Beamline Status

Previous Readiness Review Beamline Recommendations

J. Dunne -- SANE Readiness
Review

Polarized Target Upstream Beam Girder

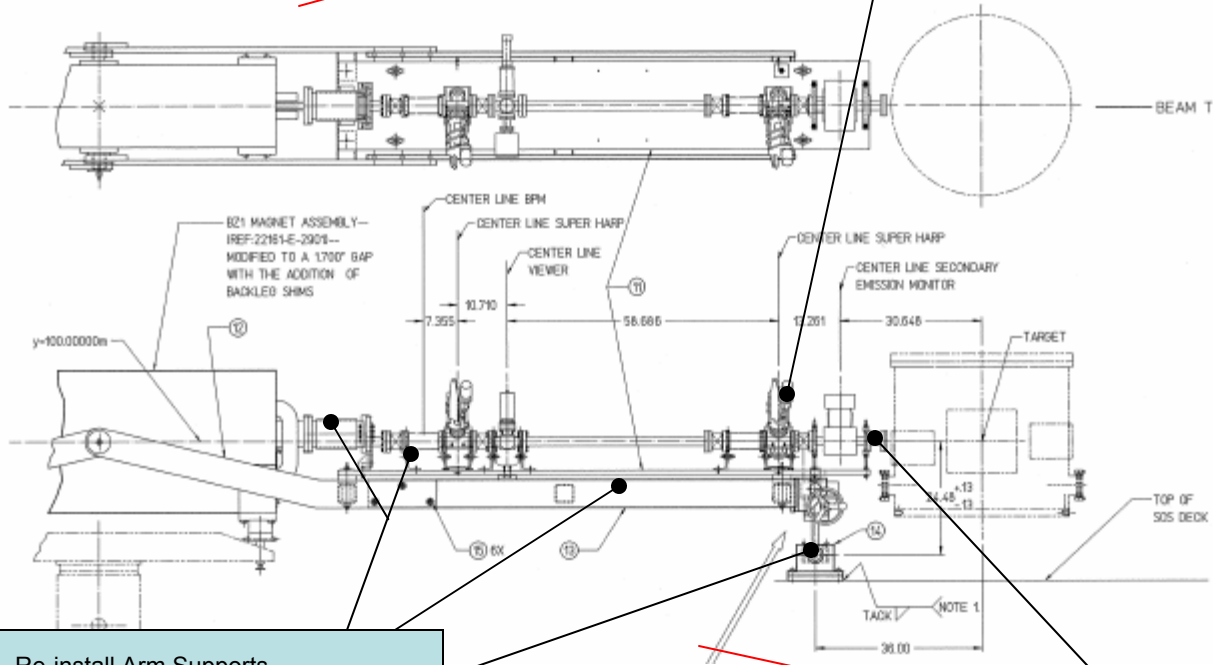
~~Proposal #2: Replace Superharp with SEM and SEM with Radiator device. Support Structure changes and Operations Approval Required~~

With little chance of WACS experiment to run, plan is to leave polarized beam line girder as is and not install the radiator.

Re-install Arm Supports, Jack, Large bellows (check condition), and girder

Beam Dump

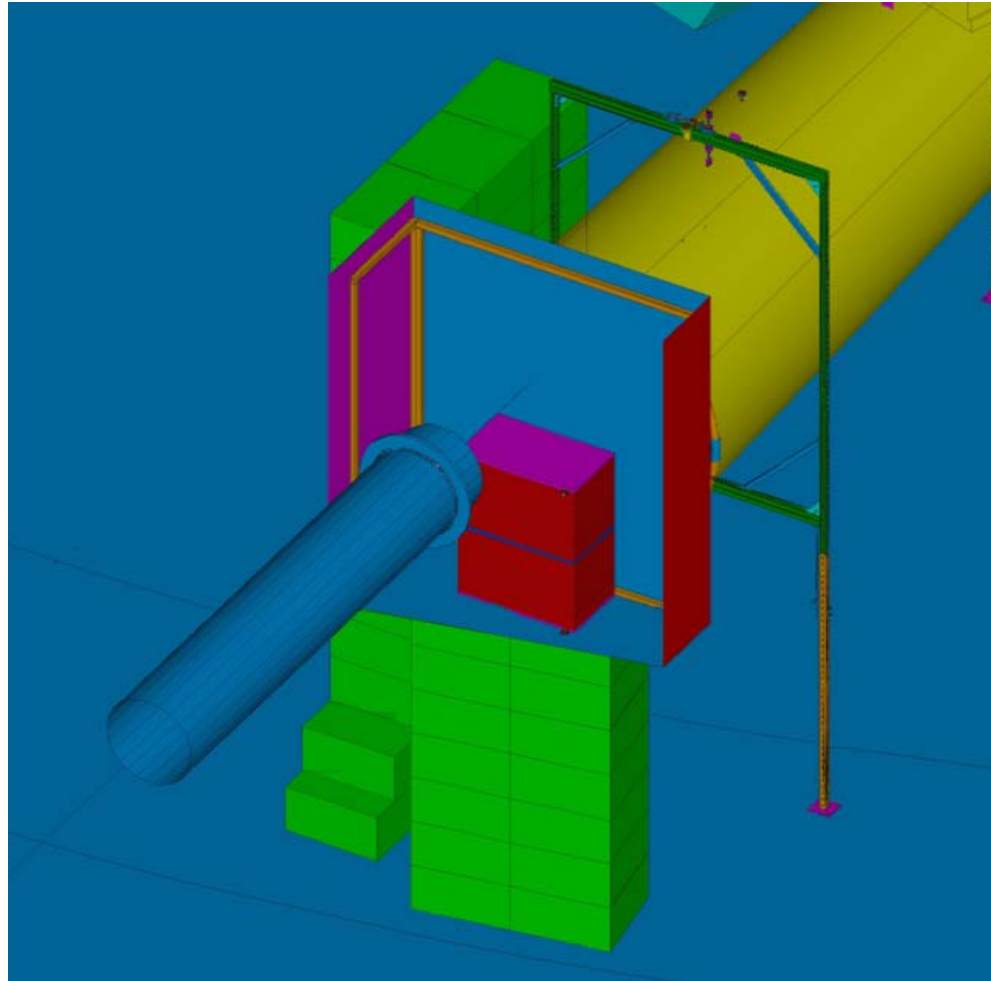
- There should be a low current (nA) diagnostics package of some kind to verify beam position from the target to the dump.
 - Install two ion chambers (left and right of the beam) between the temporary dump and the rear window of the helium bag

Walter has drawings for dump, will be installed after the G0 magnet is removed.

Two ion chambers tied to FSD's will be to the left and right of the beam between the temporary dump and the rear window of the helium bag.
